# SAFETY RECALL

Volvo Trucks North America

Date	Number	Release	Page
11.2025	RVXX2508	01	1 (3)

## Door Does Not Open from Inside VN (4)

**Parts**

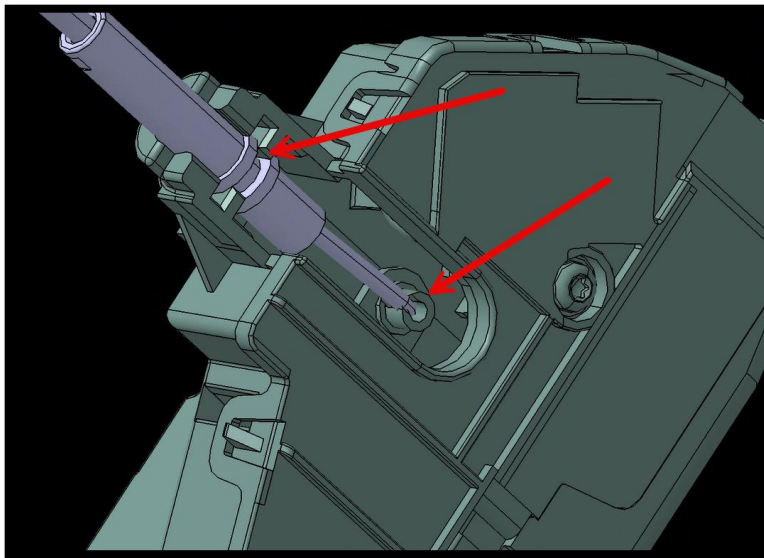
To correct this non-compliance issue, it's required that the driver's and passenger's door lock cables be replaced with new updated ones.

Part Number	Part description	Quantity
26053237	Repair Kit (2 cables & 2 Clips)	1

**Note:** On step 29, replace the existing clip with the new one provided in the kit. Make sure the cable is fully seated in the new clip and securely fastened within the latch assembly body.
